Pursuant to the provisions of Title 20, California Code of Regulation, Genesis Solar LLC, a Delaware limited liability company, hereby submits the **Genesis Solar Energy Project Application for Certification Data Request Responses to Set 1A**. The Genesis Solar Energy Project is a 250 megawatt solar electric generating facility to be located between the community of Desert Center and the city of Blythe in eastern Riverside County, California.

These 227 responses were compiled in response to the Energy Commission's Genesis Solar Energy Project (09-AFC-8) Data Requests, Set 1A, dated November 13, 2009 and posted November 16, 2009. This document provides the additional information necessary to fulfill the Application for Certification data requests for the following technical areas:

**APPLICATION FOR CERTIFICATION FOR THE  
 GENESIS SOLAR ENERGY PROJECT**

**Docket No. 09-AFC-8**

### BIO-DR 99 A Observed Ribbed Cryptantha and Approximate Boundaries of Suitable Habitat

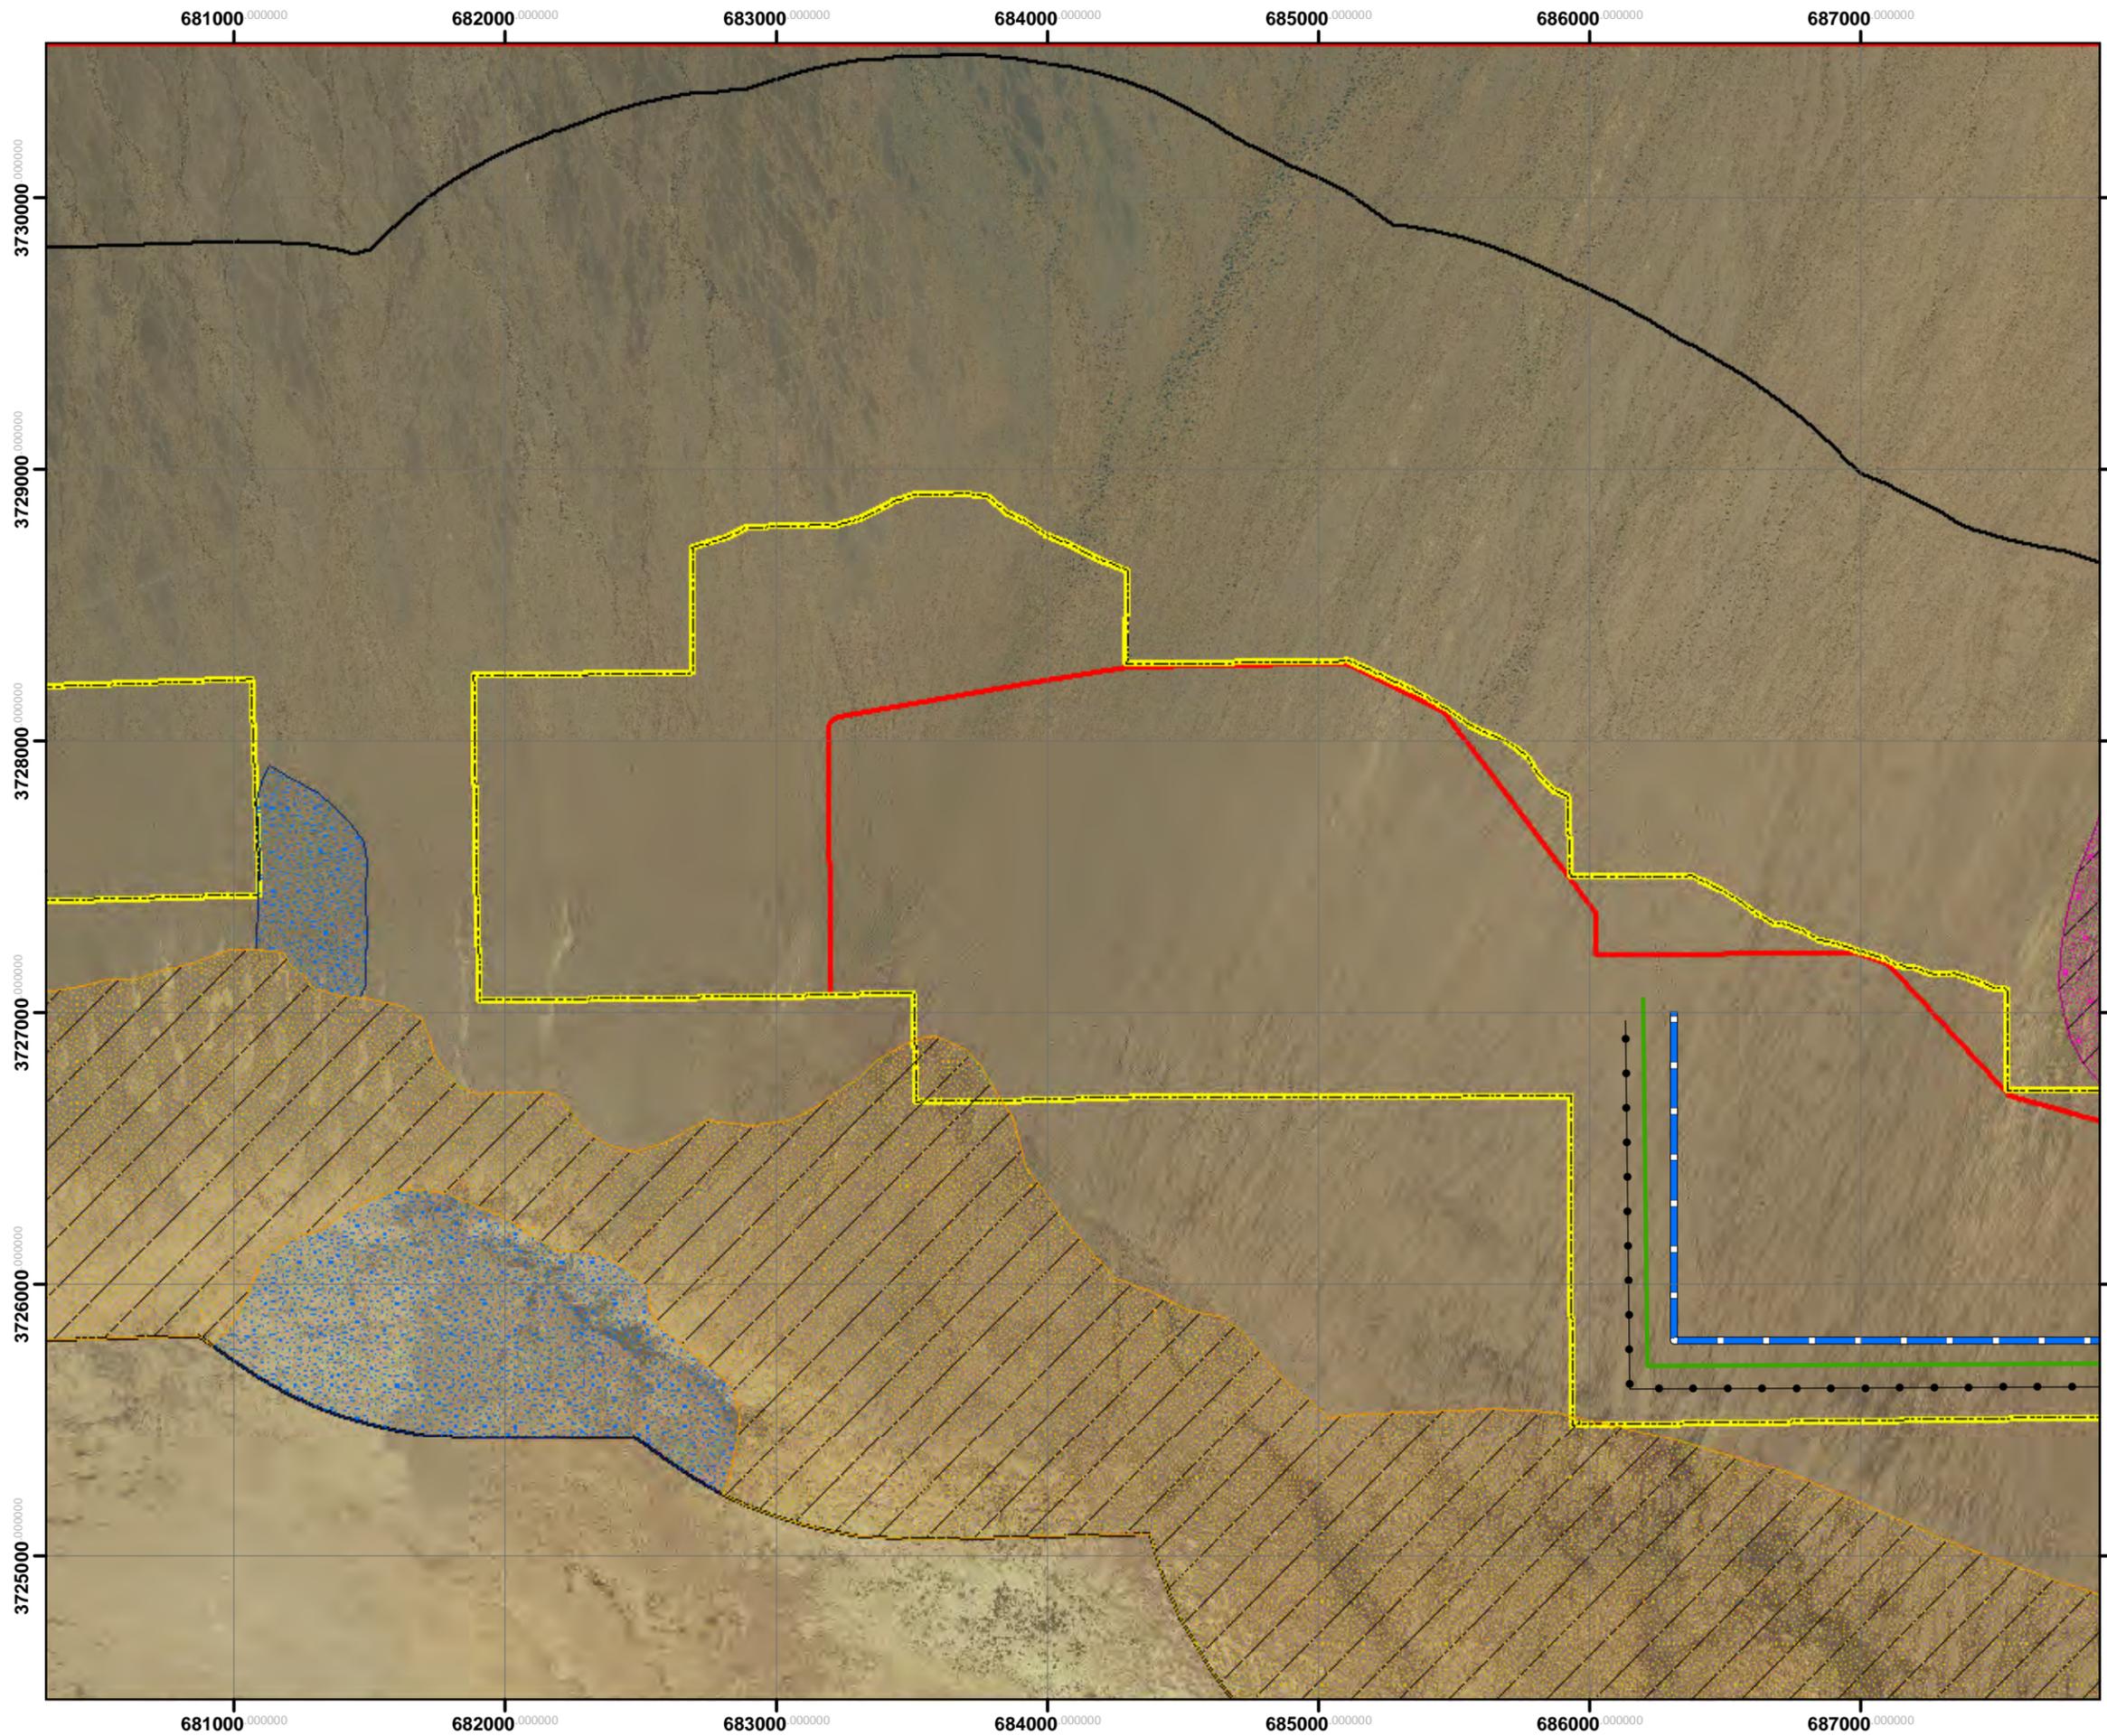
- a. Include an estimate of the number of plants observed and describe their location/distribution in the project area.
- b. Depict the approximate occurrence boundaries on an aerial photo at a scale and level of detail similar to that submitted in the Data Adequacy Supplement, Figure 5.3-6.

**BIO-DR 102 B**  
**Approximate Boundaries of**  
**Suitable Habitat for *Cryptantha holoptera***

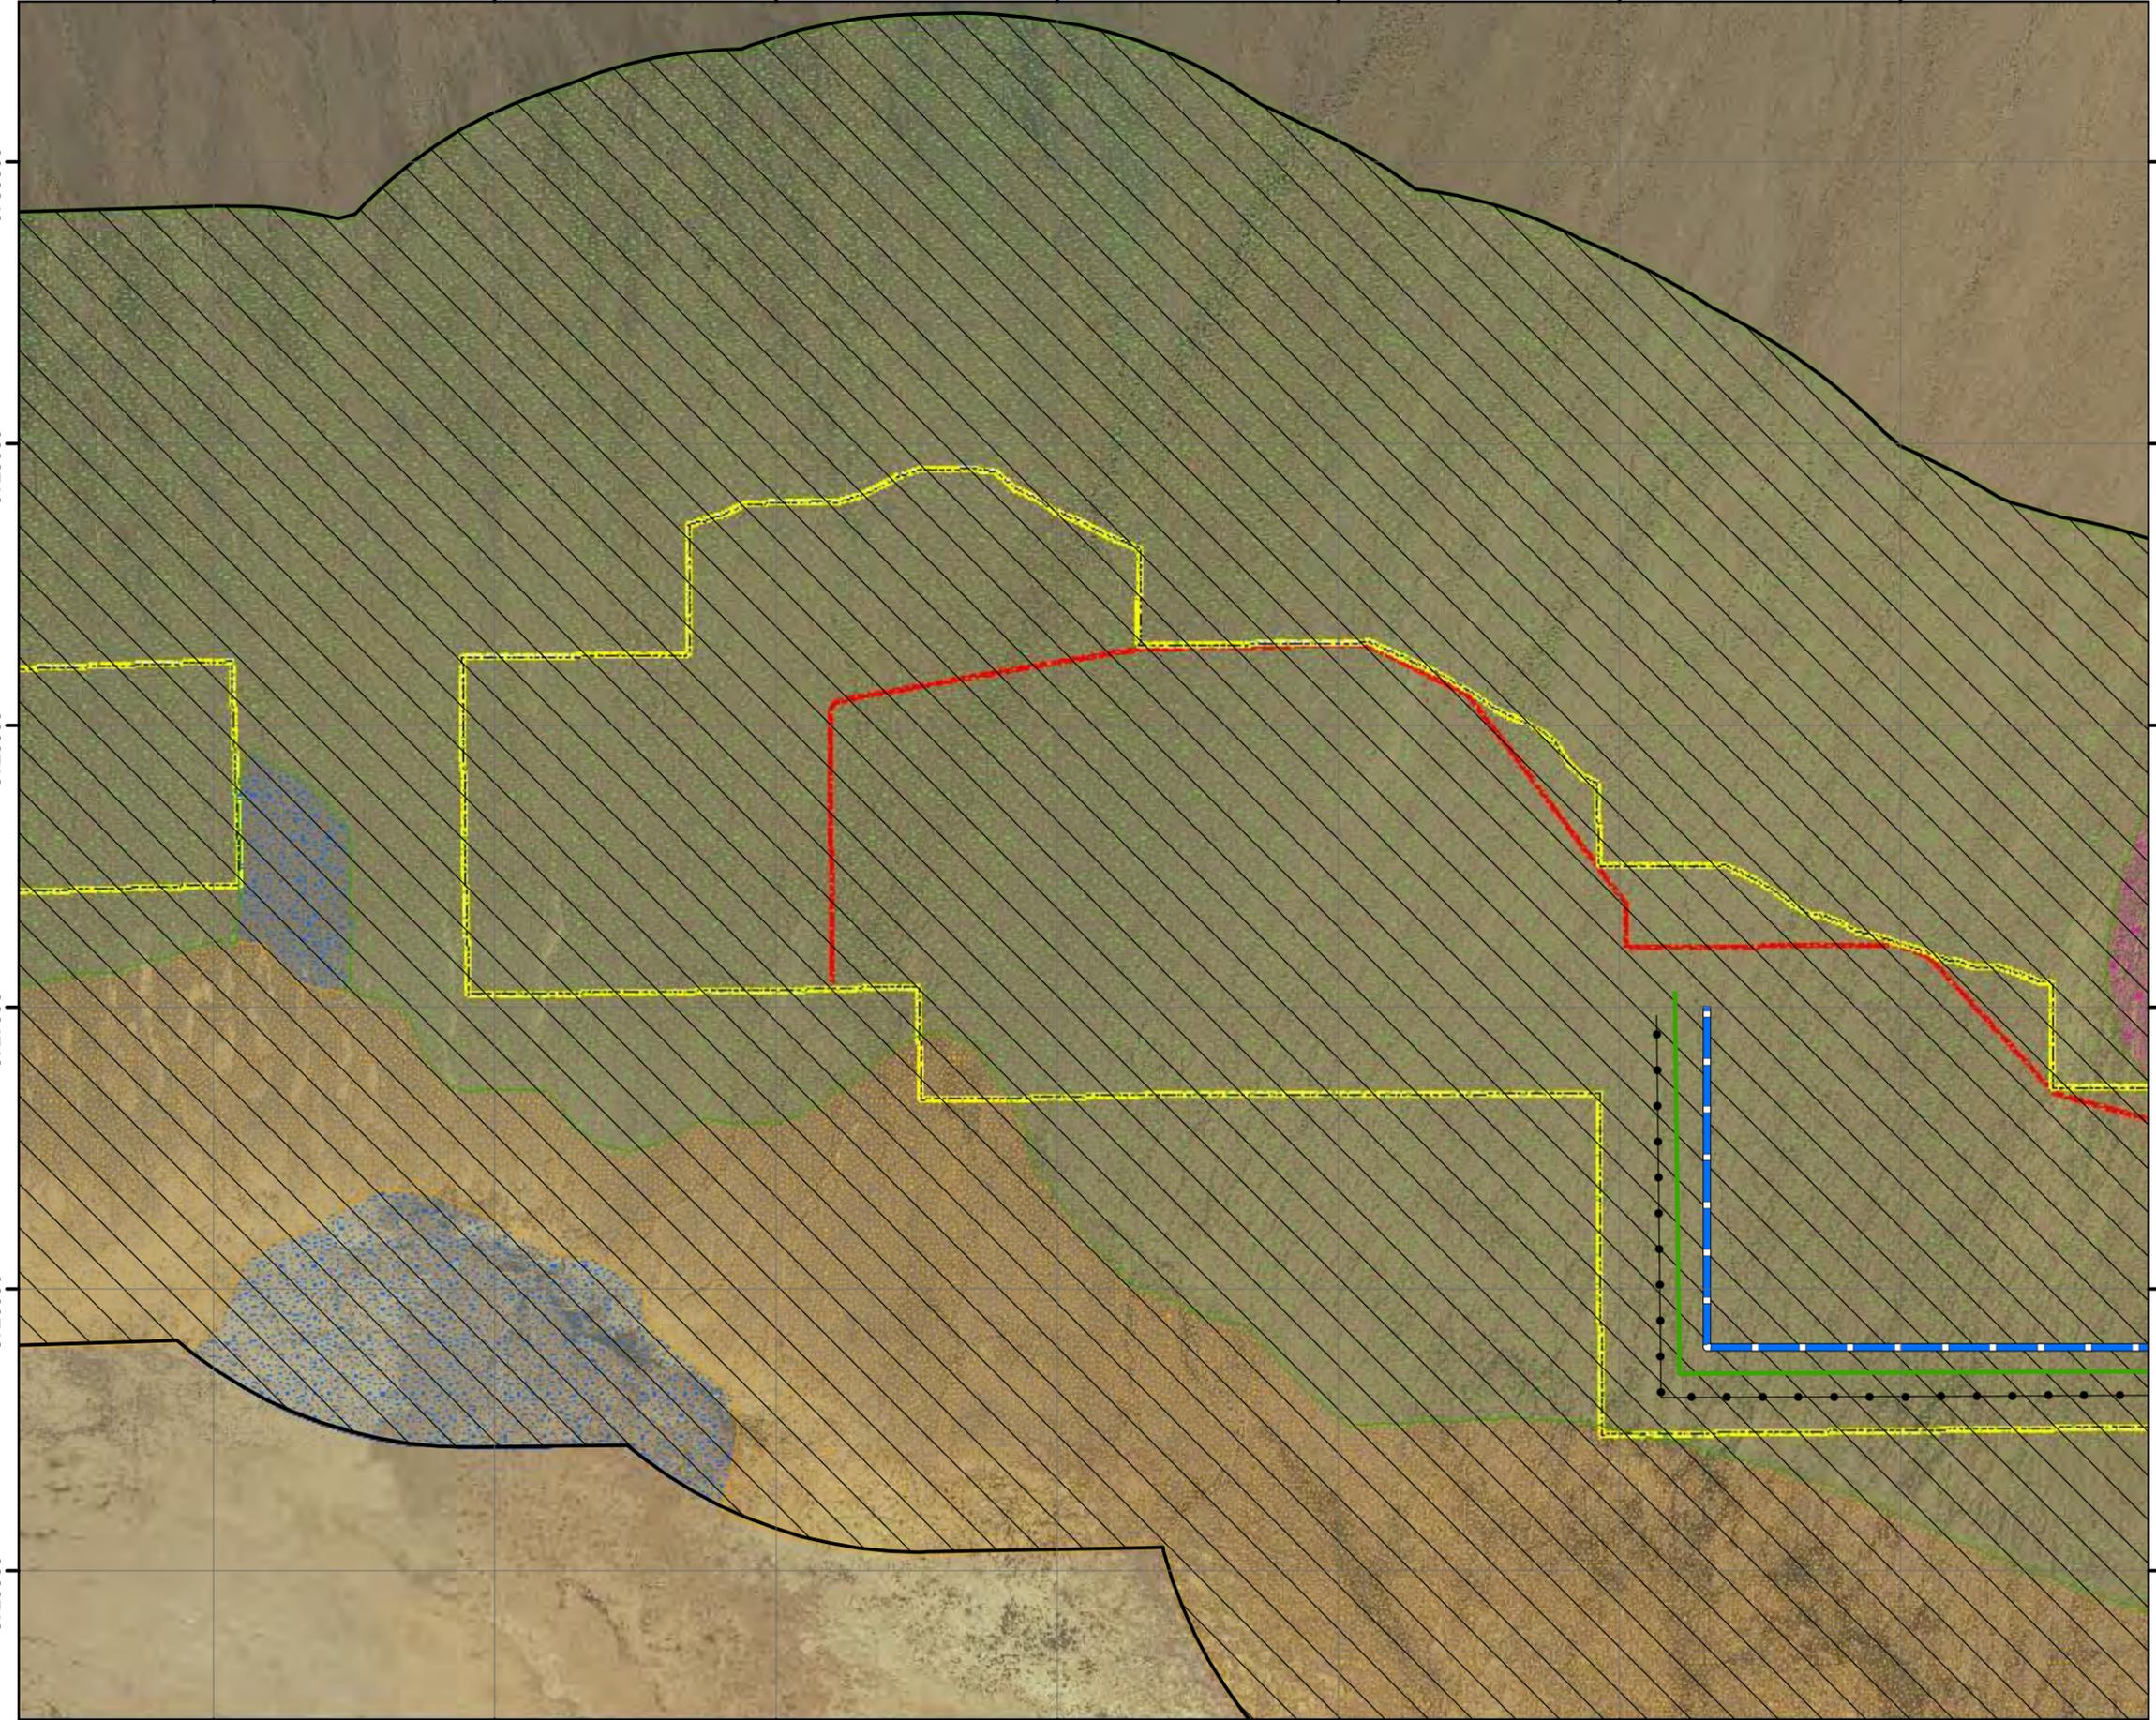
- b. Provide a map showing the location of suitable habitat (if present in the project area) on an aerial photo at a scale similar to that submitted in the Data Adequacy Supplement, Figure 5.3-6.

*Cryptantha holoptera* has suitable habitat throughout the Project footprint (Figure DR-102A-E), although none was observed during the spring surveys. (Table DR-102).
